GRINNELL COLLEGE
FORUM ADA EVALUATION

February 11, 2011

non-compliance evaluation

NON-COMPLIANCE EVALUATION – EXISTING LOWER LEVEL PLAN

UPPER LEVEL CONCEPT PLAN

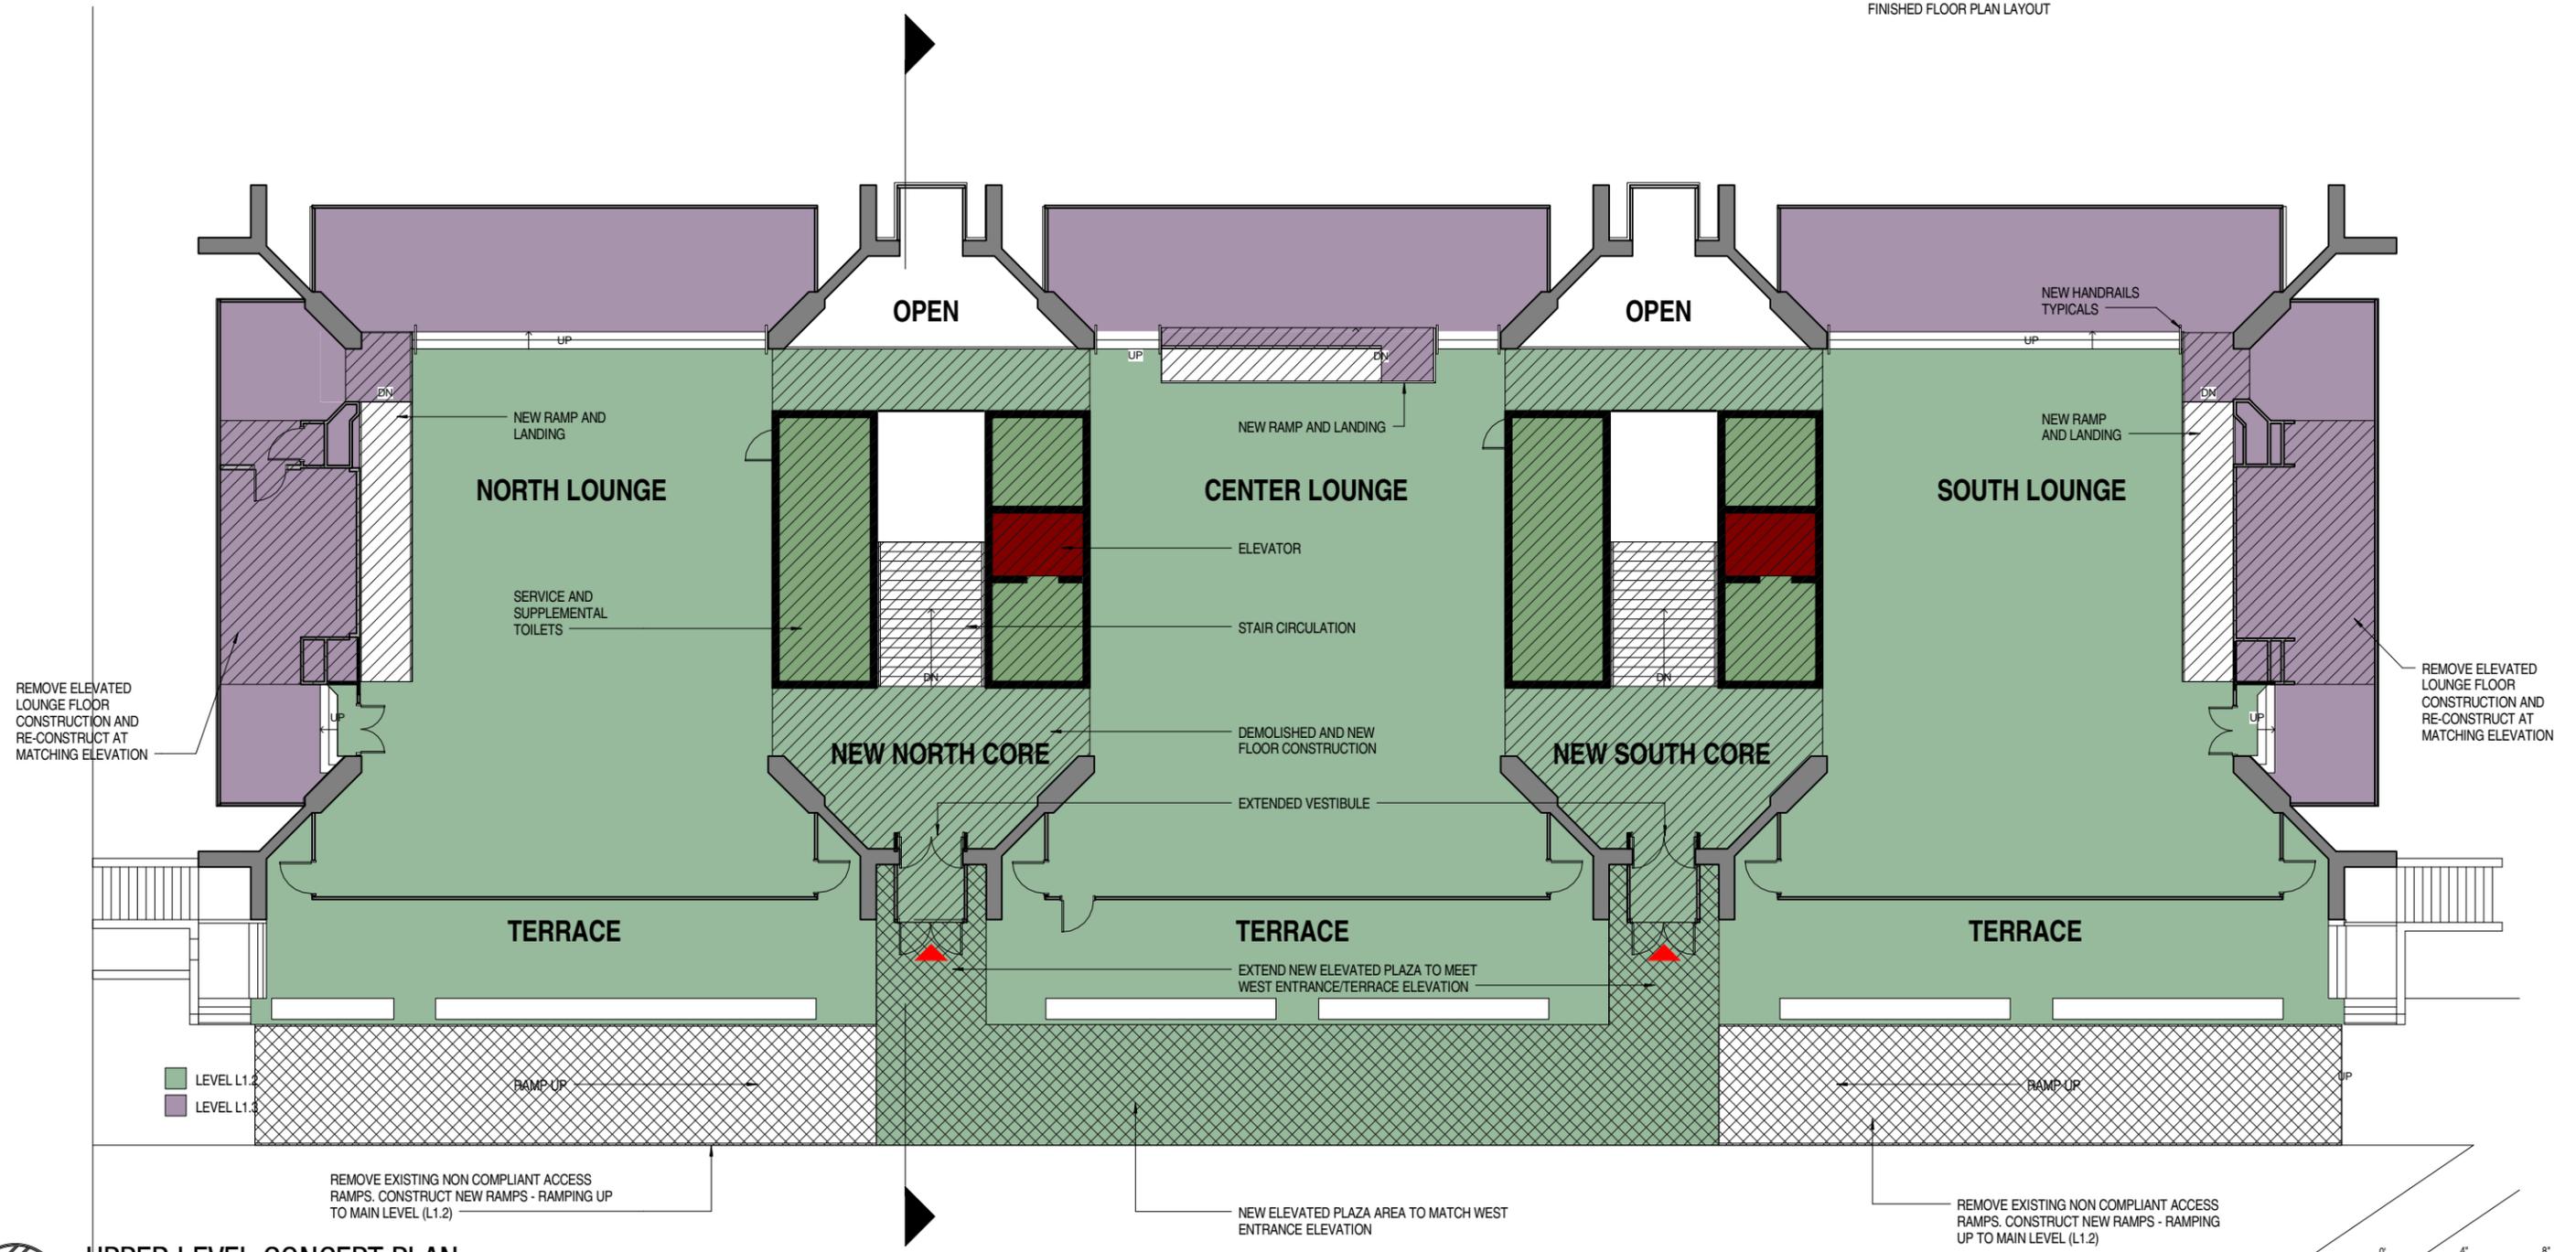
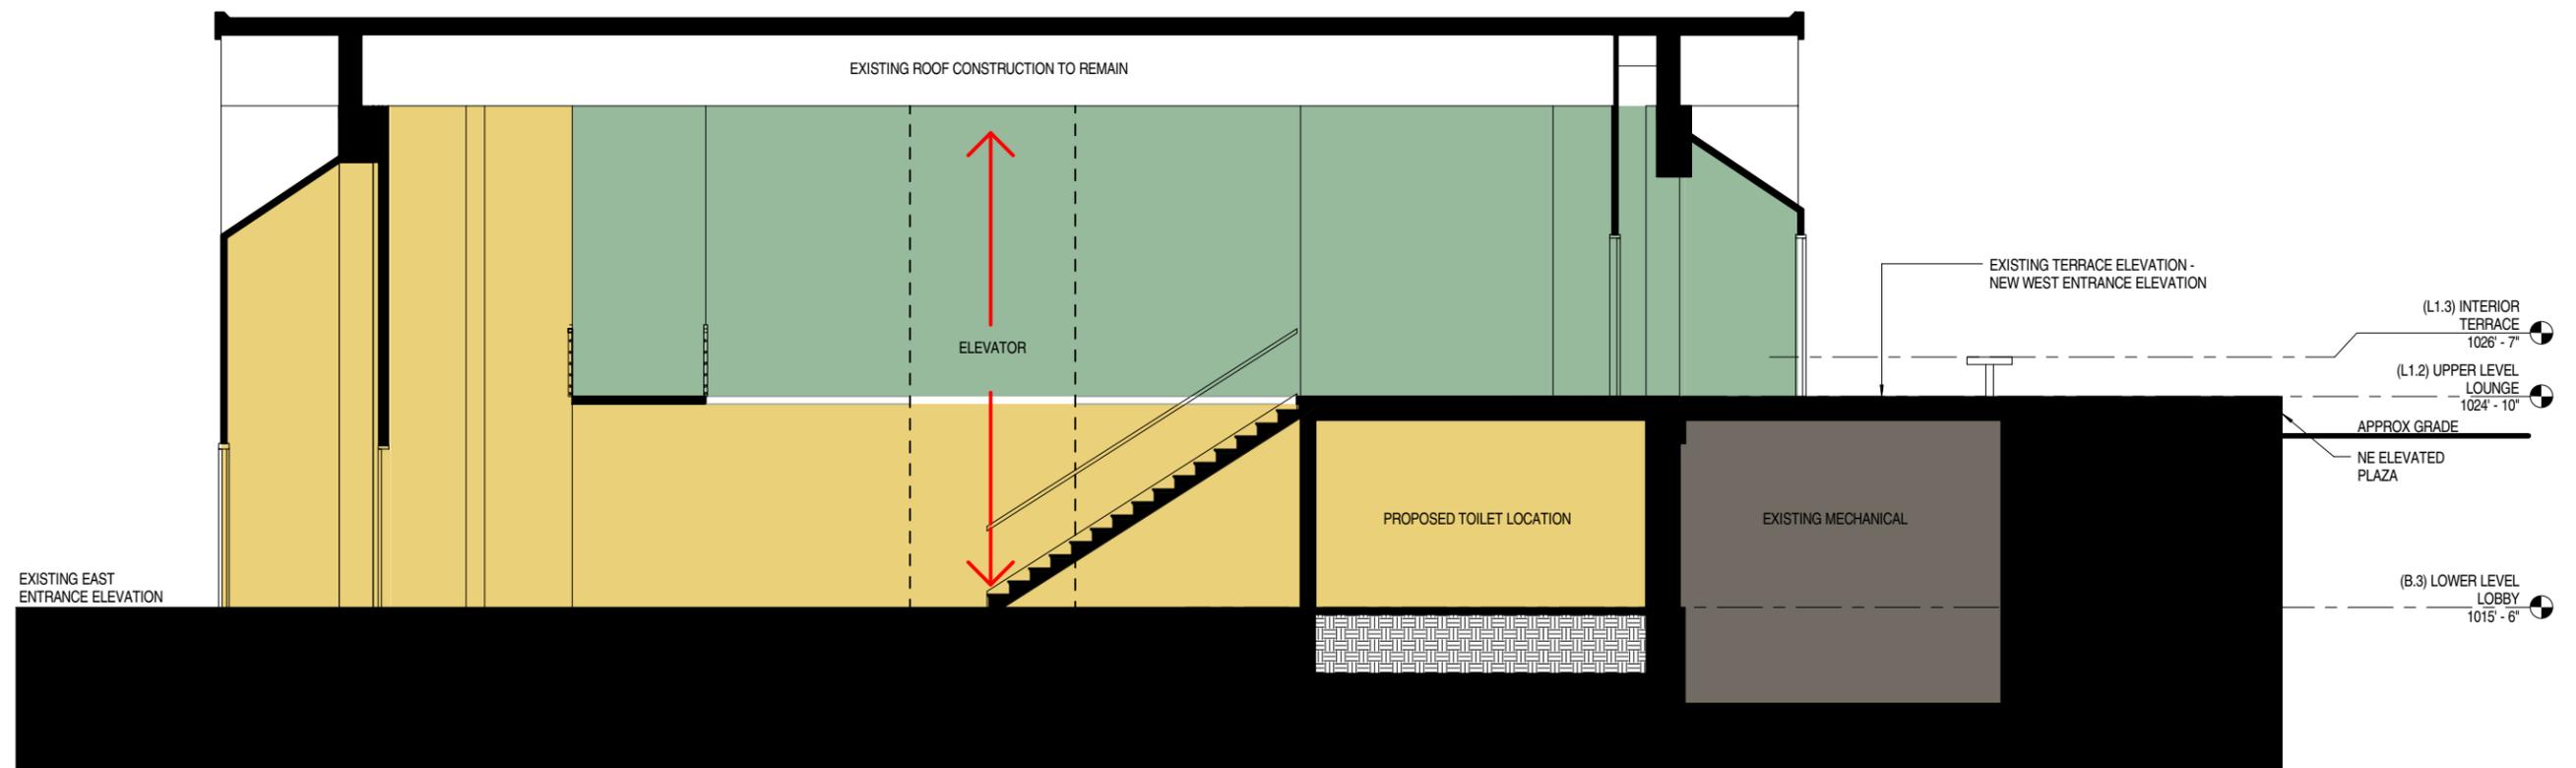
The following diagrams illustrate a remodeling strategy to bring the building into ADA compliance. The concept is based upon the removal and re-build of the two central circulation core areas to provide complaint vertical circulation to each primary level of the building with new stairs and elevator(s). In addition, the site would be modified at the west side of the building with a ramped terrace to provide an at-grade entrance. Remaining incidental elevated areas on the upper level would be accessed by new ramp construction. This concept is put forth without a detailed structural analysis, mechanical/electrical evaluation or a detailed code study at this time, but it appears to be a viable strategy for acheiving accessibility goals.

A remodeling of this scope would likely be classified by the International Existing Building Code as a “Level III” modification, requiring upgrade to meet current building code standards, including mechanical, electrical, and plumbing systems.
